***RE: Comments in Response to the Cuyahoga River Ecosystem Restoration Canal
Diversion Dam Project Environmental Assessment***

USEPA and USCOE comments and response – United States Environmental Protection Agency (September 28, 2016) and United States Army Corps of Engineers, Regulatory Branch (October 7, 2016) reviews.

NPS response to request for additional information (November 28, 2016)

PEPC SHPO comments – Response to September 30, 2016 State Historic Preservation Office Review

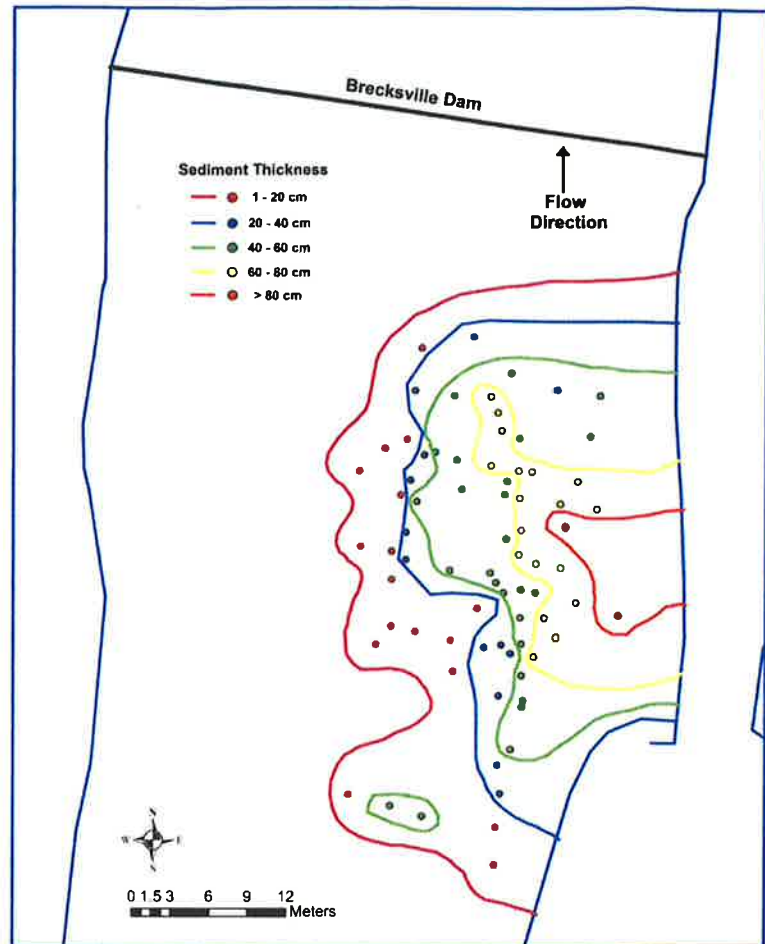
Comment

There is no anticipation of a knickpoint forming following removal of the Canal Diversion Dam. As can be easily noted in the historic photo below, the Canal Diversion Dam sits atop a natural bedrock outcrop. The photo below depicts the Pinery Dam. The Canal Diversion Dam was constructed downstream of the exposed bedrock. Additional information and clarification on this comment was added to section 4.2.3.3

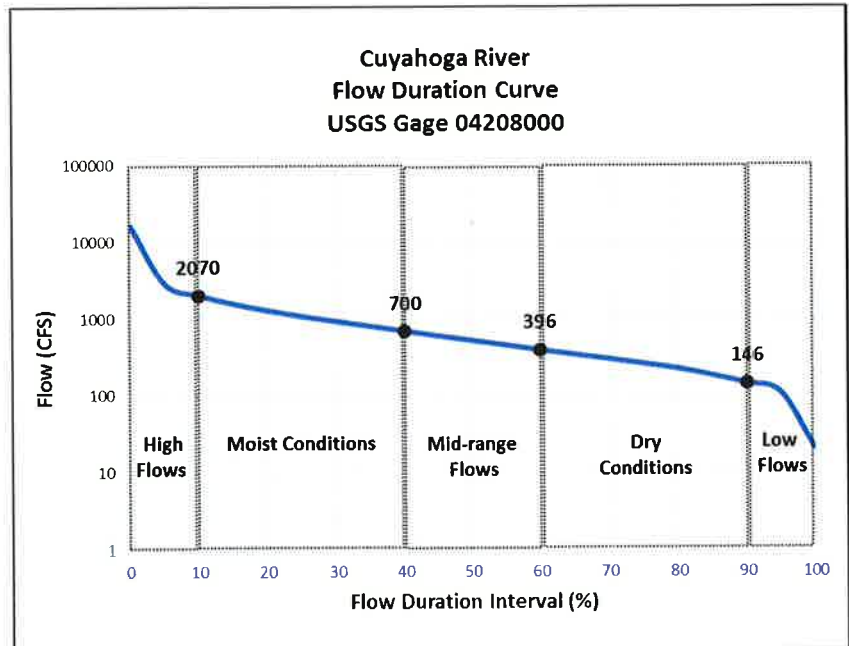
There were several comments received related to sediment accumulated in the dam pool. They will be grouped into two categories: chemical composition and volume.

The thickest sediment is located near the intake gates for the Ohio and Erie Canal. Based on the information provided in the 2010 study, a volume of 521.5 m³ can be conservatively calculated within the lower section of the dam pool. This can also be expressed as 682 cubic yards or approximately 947 tons.

In order to put this volume of material into perspective a flow duration curve was developed for the Cuyahoga River using the USGS Independence gage. The curve utilized gage data from 1921-2016 comprising 31,609 data points. A flow duration curve ranks daily flow values based on percent exceedance of a certain value. A curve was developed using USEPA's "An Approach for Using Load Duration Curves in the Development of TMDLs" (USEPA 2007). In addition to flow data, total suspended solids (TSS) was also monitored at the gage, although not for every flow value. A discharge load value could be calculated for TSS

discharge at the gage. There were 16,535 data points where TSS was monitored along with flow. This data represents 1260 results in the low flow interval, 5158 in dry conditions, 3422 in mid-range flows, 5080 in moist conditions and 1615 within the high flow interval. The loads calculated are included in the following table. Loading calculations indicate that on days with elevated flows, exceeded 40% of the time, on average, 1,441 tons of suspended solids are moving past the Independence gage each day. This includes mostly fine particle sizes generally originating from resuspension, channel erosion, and nonpoint sources. Data was also examined from the National Center for Water Quality Research at Heidelberg University. They have monitored TSS almost daily at the USGS Independence gage (89.6% of the days between 1982 and 2015). Based on their data, the average daily amount of TSS passing by the USGS Independence gage is 604 tons. Using the Heidelberg data to generate loading calculations indicated that on days with elevated flows, exceeded 40% of the time, on average, 2,168 tons of suspended solids are moving past the Independence gage each day. From an environmental standpoint the volume of fine sediment is minimal and does not pose an ecological risk to the Cuyahoga River. Reestablishing a free-flowing river will also restore the natural sediment transport function of the river.
